PHILCO . . . . RADIO SERVICE BULLETIN No. 349

Supplementary to Bulletins No. 344, 345, 346, 347

FOR MODELS 715, 41, 44 and 408

Schematic Diagram — Model 408 I.F. Frequency 460 K.C.

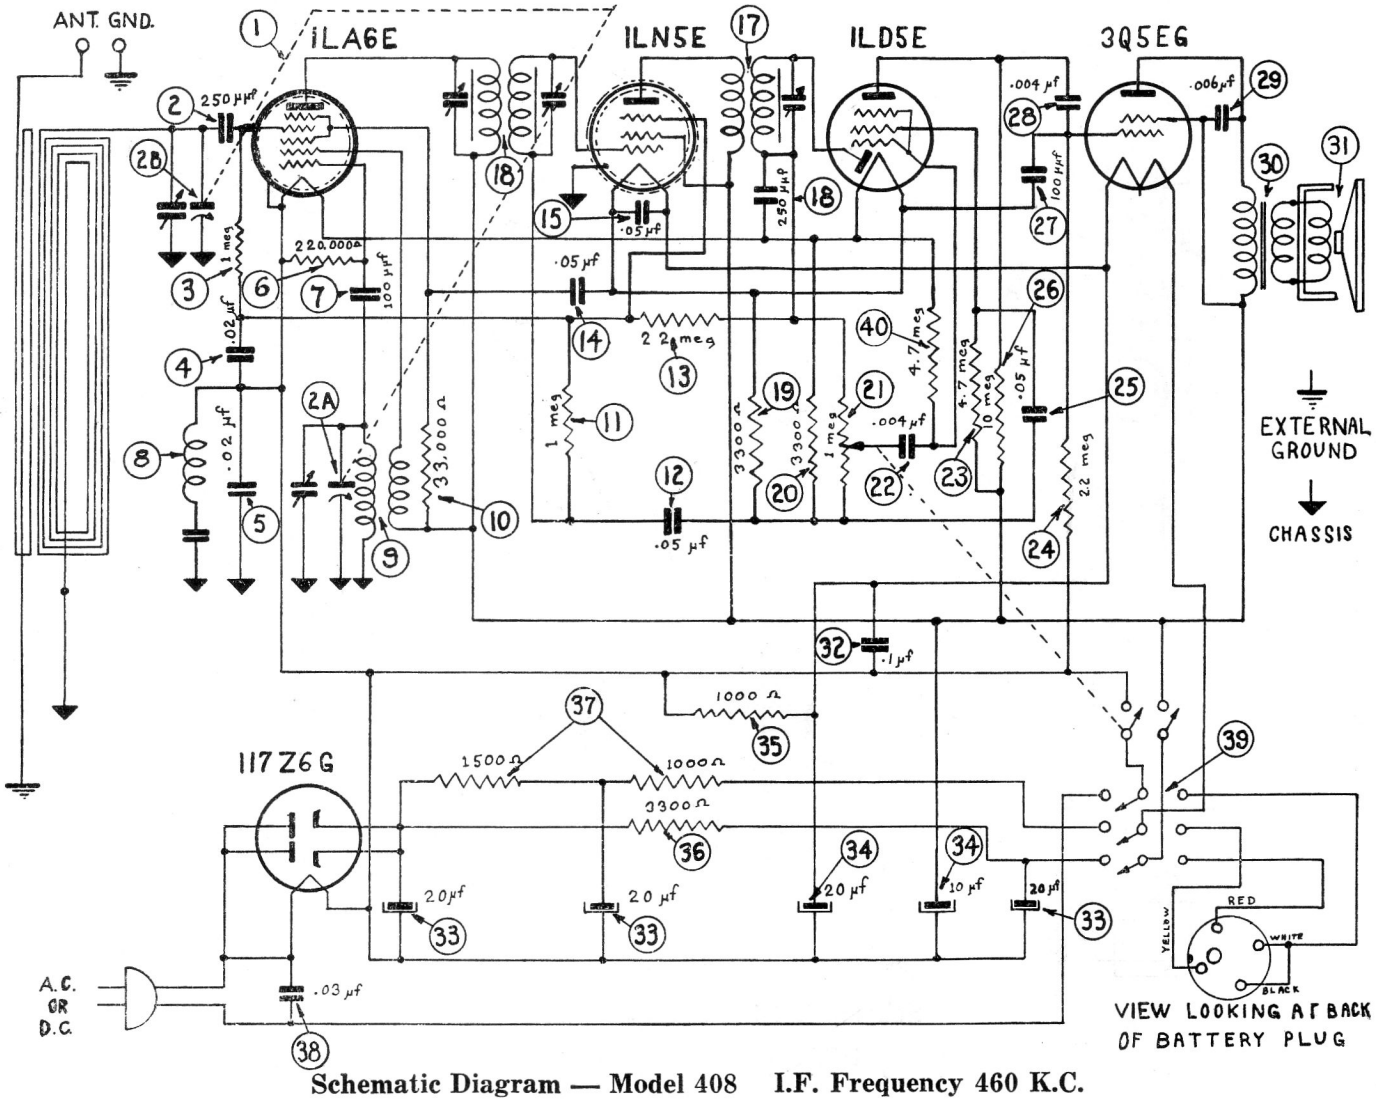
Various changes have been made in production on Philco Models 715, 41, 44 and 408 in order to improve their performance. The new schematic diagrams for these models are on the pages of this bulletin, and should be used instead of the similar diagrams appearing in bulletins numbered 344, 345, 346 and 347.
